MONTEBELLO ESTATES JSP 15-76

Public hearing at the request of Mirage Development for Planning Commission's approval of Preliminary Site Plan, Woodlands Permit, Wetlands Permit and Stormwater Management Plan. The subject property is currently zoned R-3, One-Family Residential and is located in Section 27, west of Novi Road and north of Nine Mile Road. The applicant is proposing a 32 unit single-family detached residential development on a 26.94 acre property.

Approval/Postpone/Denial of the Preliminary Site Plan, Wetland Permit, Woodland Permit, and Stormwater Management Plan.

Title:
Woodland Plan

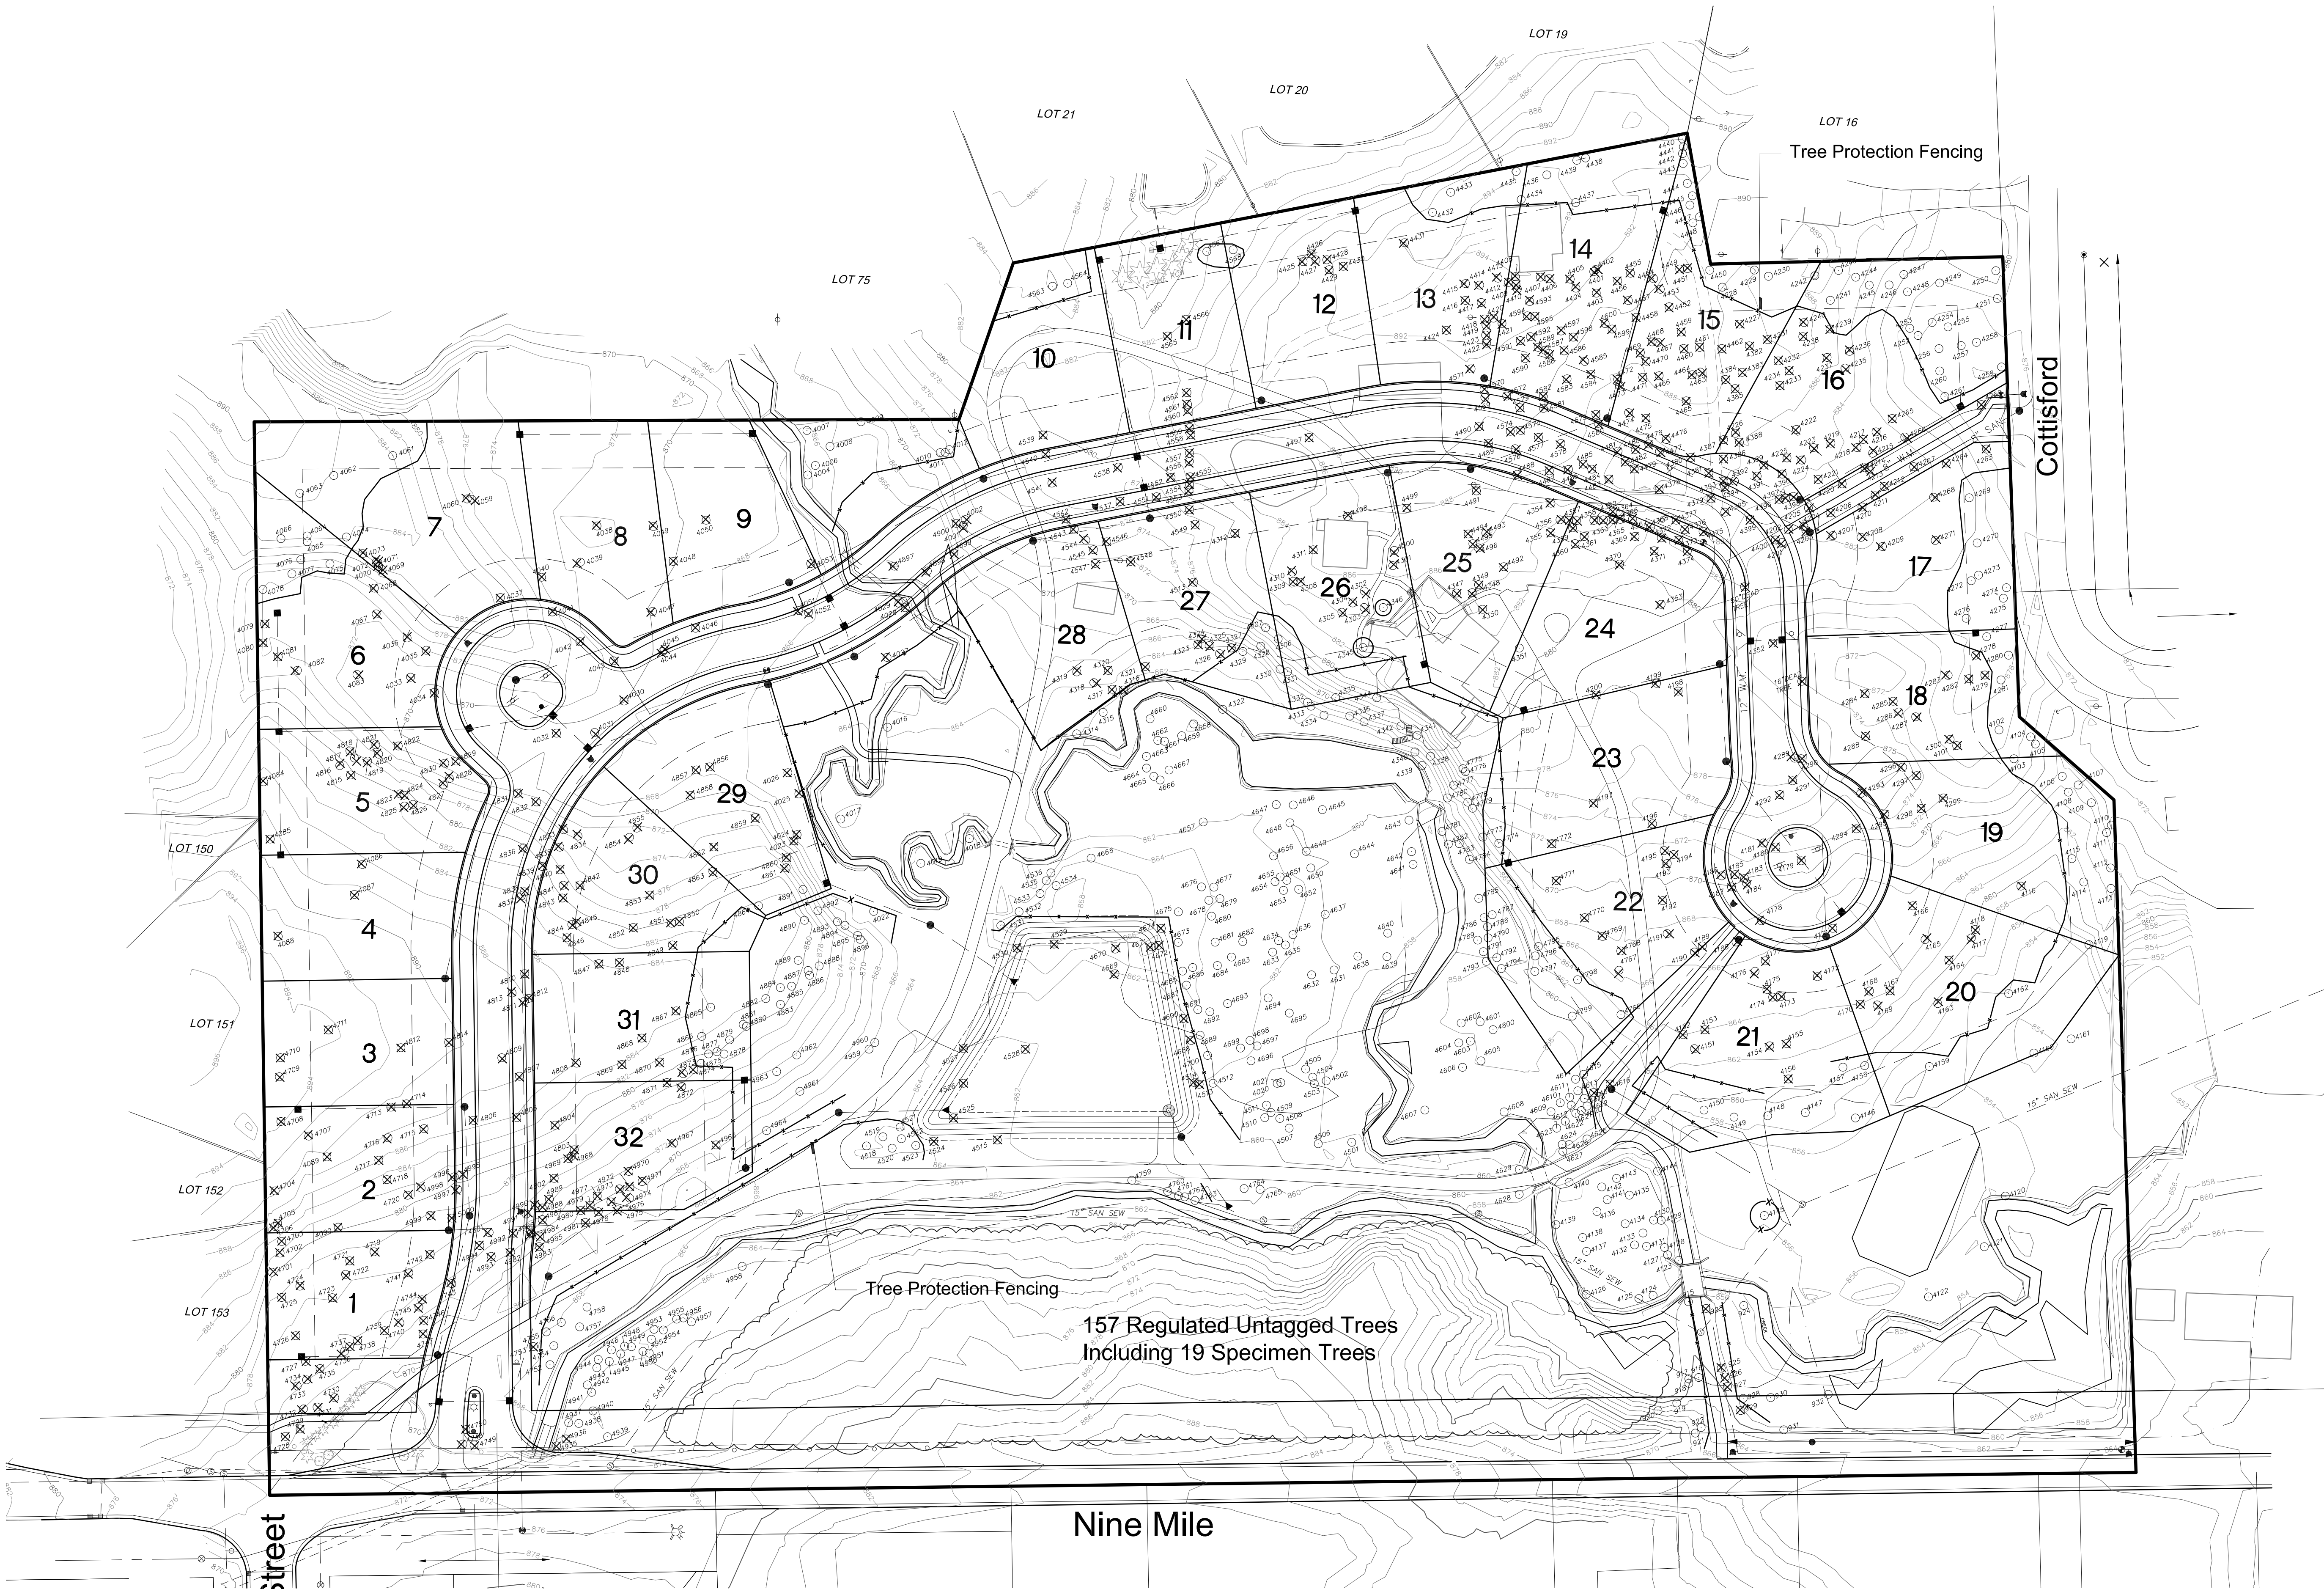
A *Woodland Plan* (Sheet L-4) and *Tree List* (Sheets L-5 and L-6) have been provided with the Plan. The existing site woodland information (tree sizes, species and conditions) has been provided by the Applicant. In addition, proposed impacts to on-site regulated woodlands have been described/quantified. Sheet L-6 (*Tree List*) includes a *Woodland Summary* that summarizes the proposed tree removals and required Woodland Replacement Tree quantities.

Figure 2. Previous iteration of Site Development Plan, provided by Seiber, Keast Engineering, L.L.C. Delineated wetland areas are indicated in green and (approximate) watercourse centerlines are shown in blue.

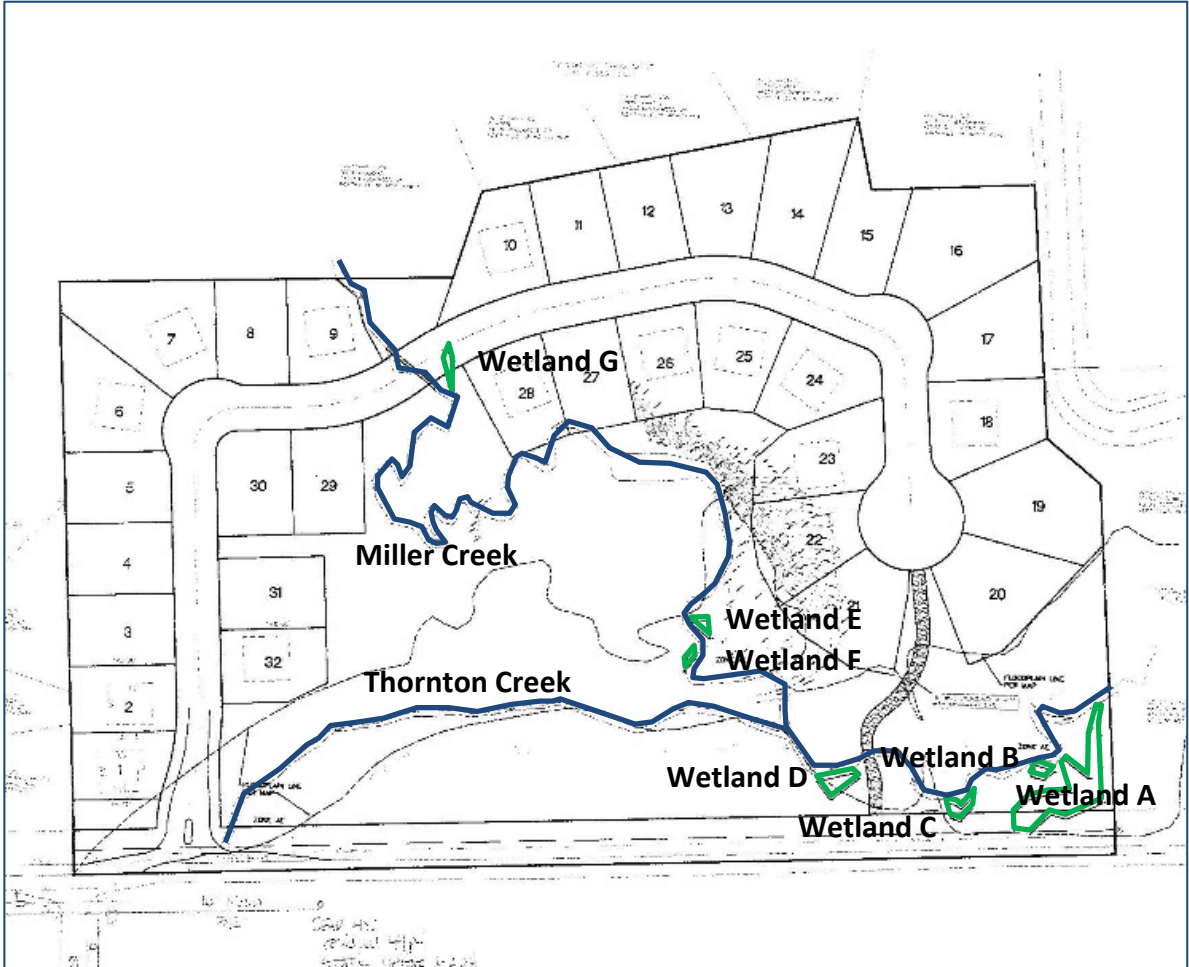
Currently, the Plan indicates impacts to one (1) of the seven (7) on-site wetlands (i.e., Wetland G, see Figure 2). The Plan proposes to fill Wetland G (0.01-acre), located in the northern section of the site, for the purpose of constructing a section of Montebello Court as well as Lot 28. The current Plan also proposes to enclose approximately 95 lineal feet of Miller Creek via a proposed 85 lineal foot culvert for the purpose of constructing a road crossing (i.e., Montebello Court) of Miller Creek. It should be noted that the currently-proposed enclosure is an improvement over the last plan submittal. The previous plan proposed the relocation of approximately 230 lineal feet of Miller Creek via a proposed 85 lineal foot culvert for the purpose of constructing a section of Montebello Court as well as Lot 29. The old plan involved the abandonment/filling of a greater length of Miller Creek, apparently in order to include an additional buildable lot (i.e., previously-proposed Lot 29).
